5440 WADE PARK BLVD, SUITE 102 WWW.BGEINC.COM NC LICENSE #C-4397 ©2023	DESIGNED BY:				
	DRAWN BY:				
	REVIEWED BY:		DF		
			DF/JWM	10/02/2023	PER TOWN OF ROLESVILLE COMMENT
				08/01/2023	PER TOWN OF ROLESVILLE COMMENT
		REV	06/01/2023	INITIAL SUBMITTAL

PARKER RIDGE
82 SCHOOL STREET
ROLESVILLE / NORTH CAROLINA / 27571

CARVED STREET CT PLAN
AND PROFILE

CULVERT 1 PLAN

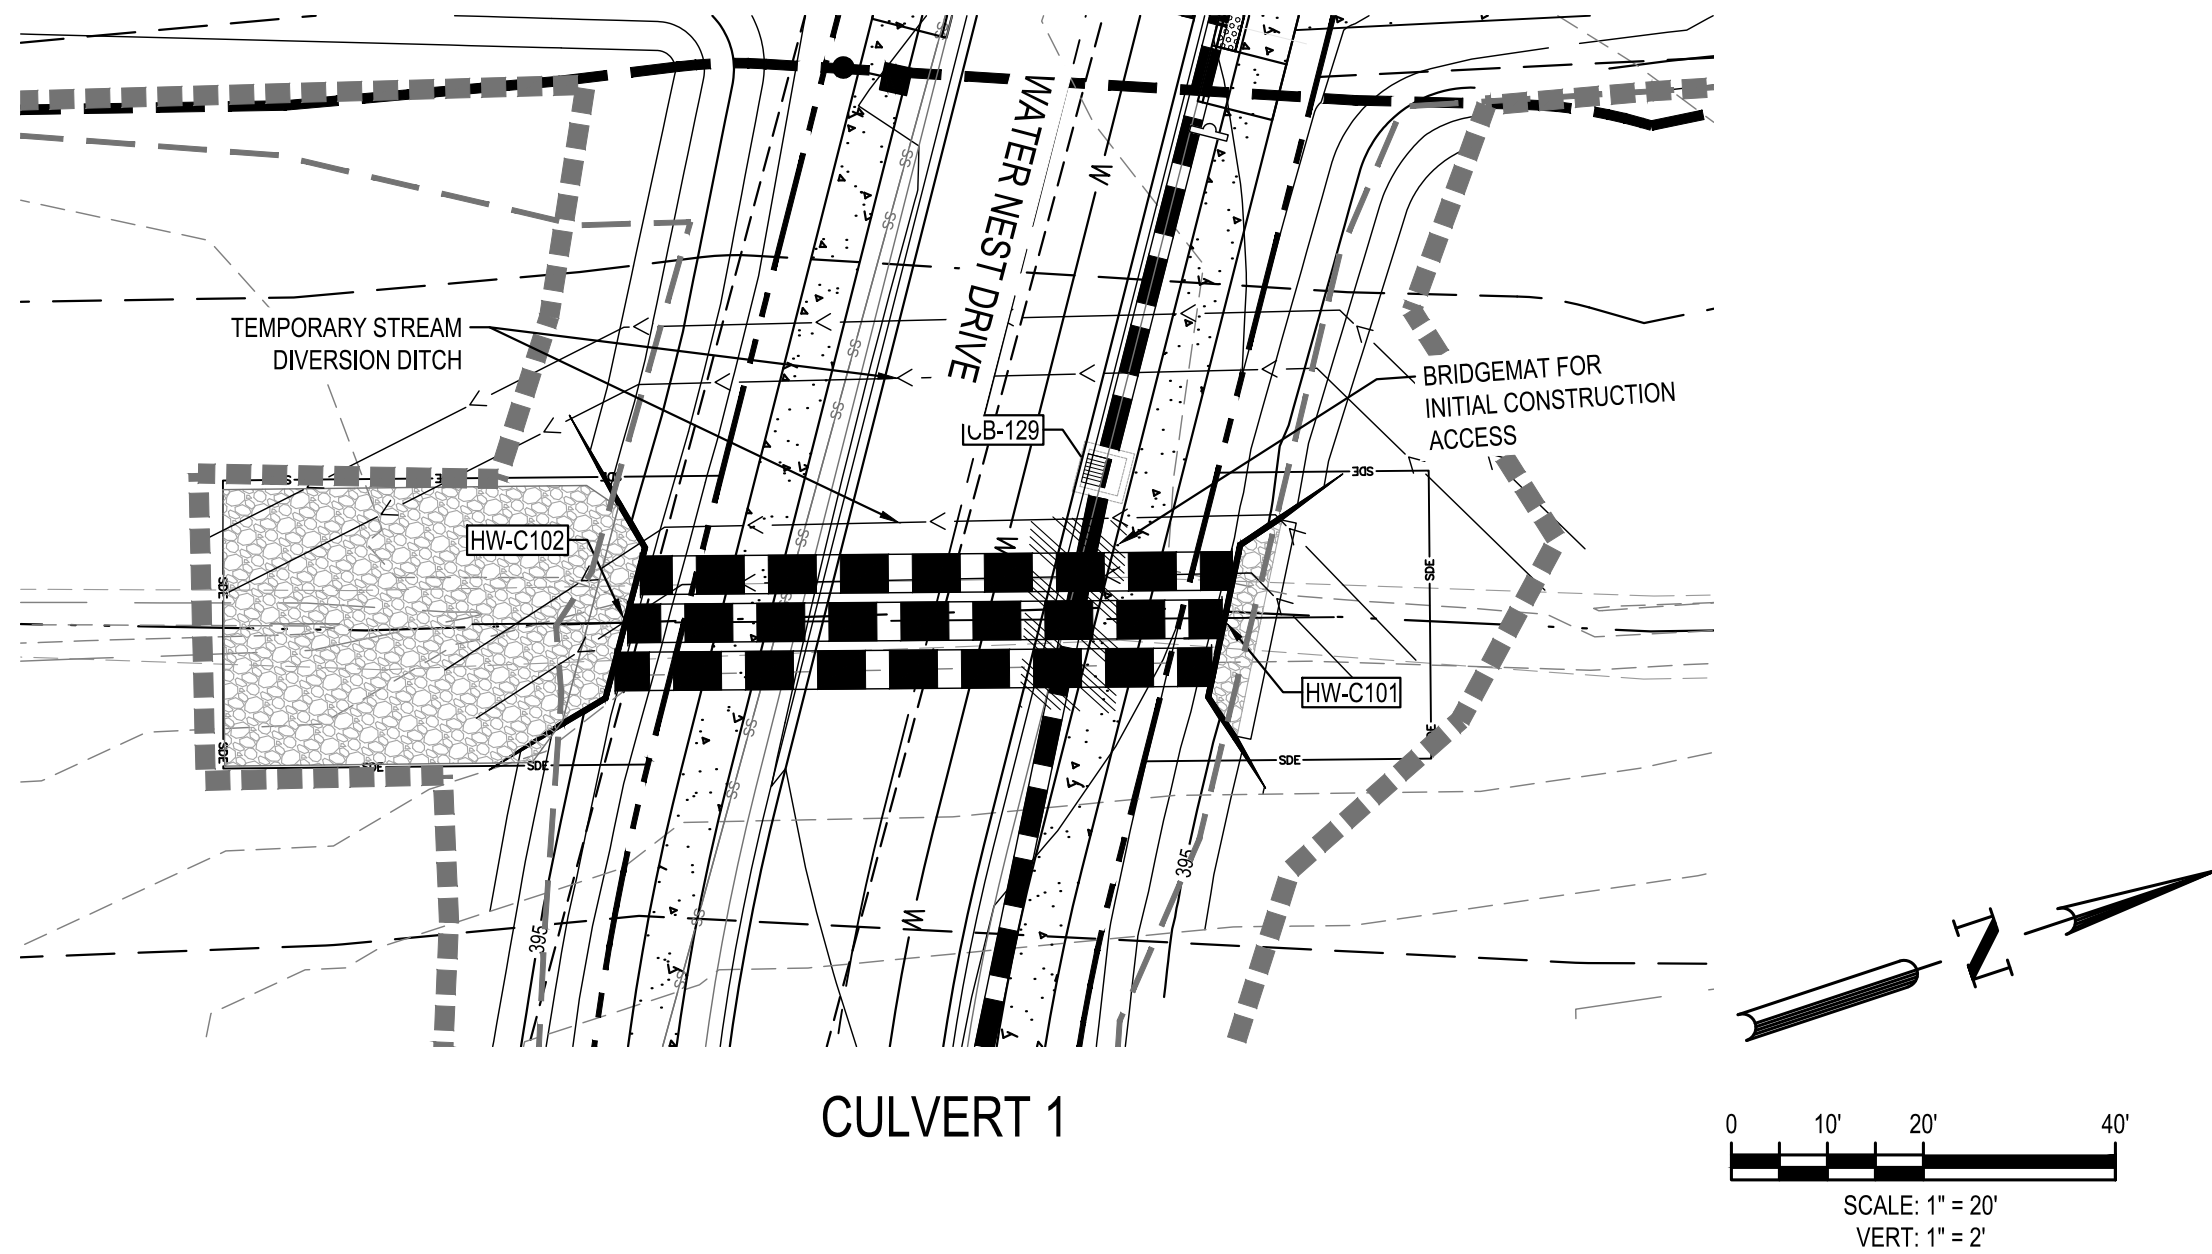
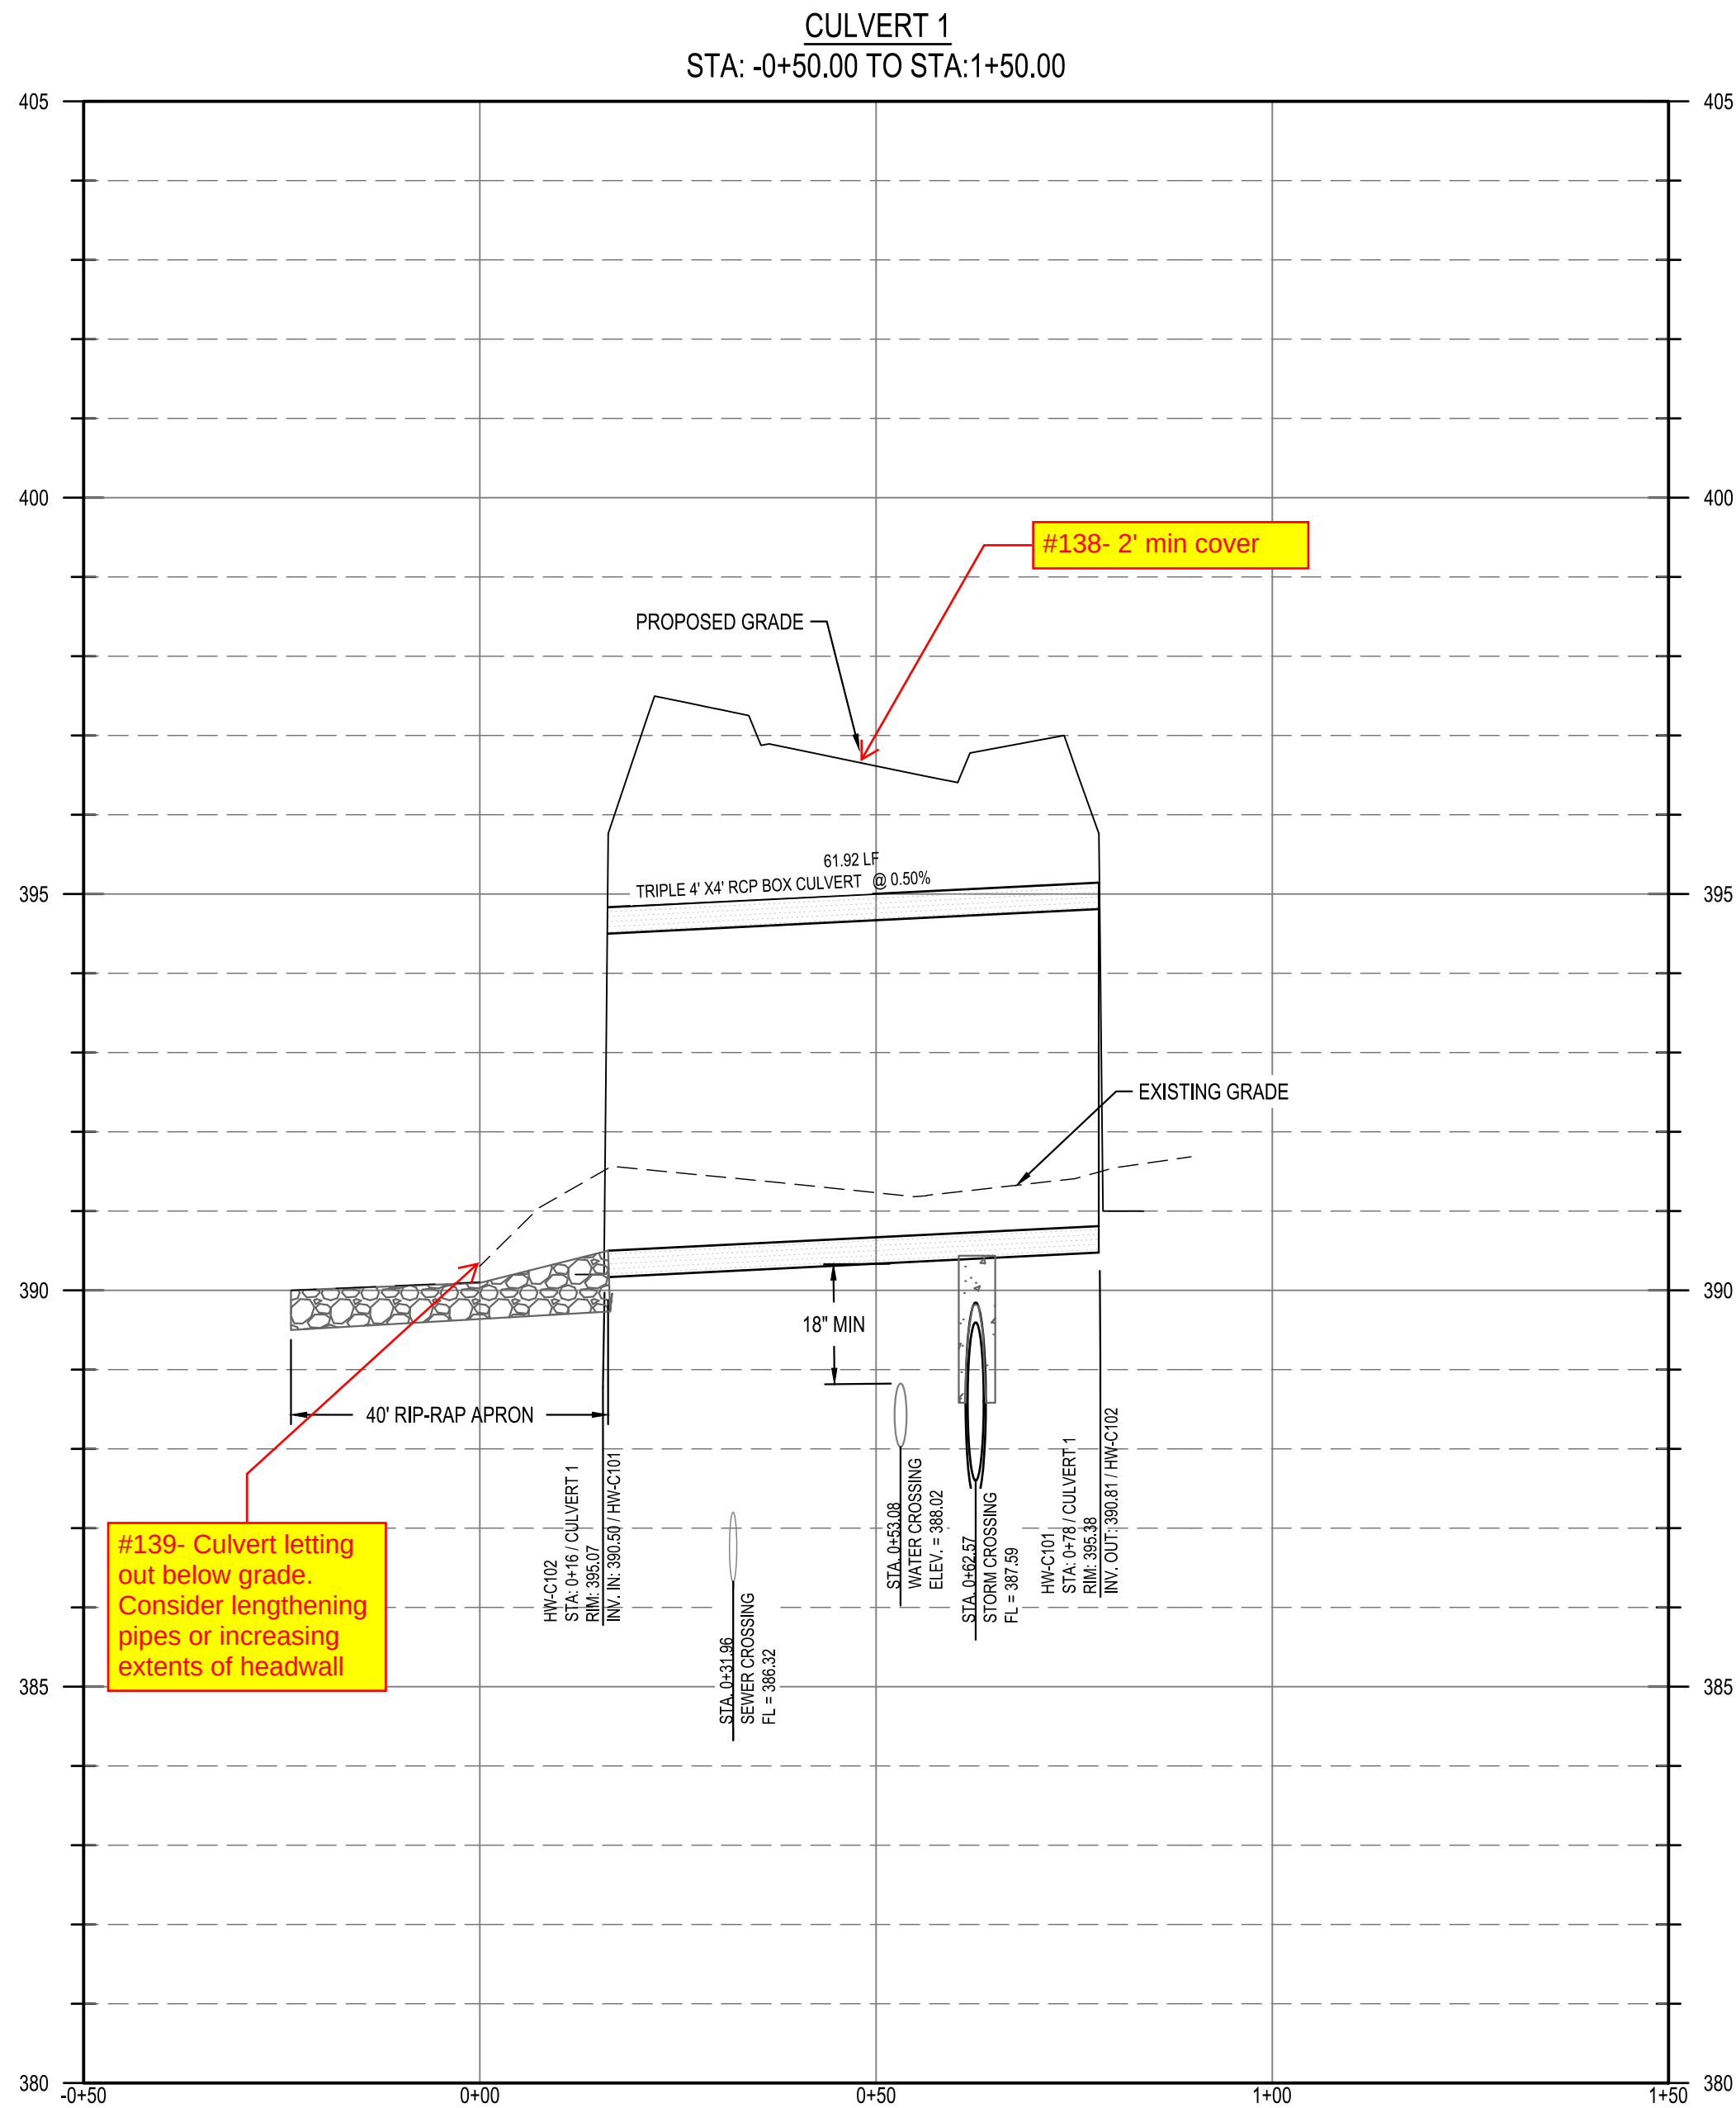
#48- Label existing contours
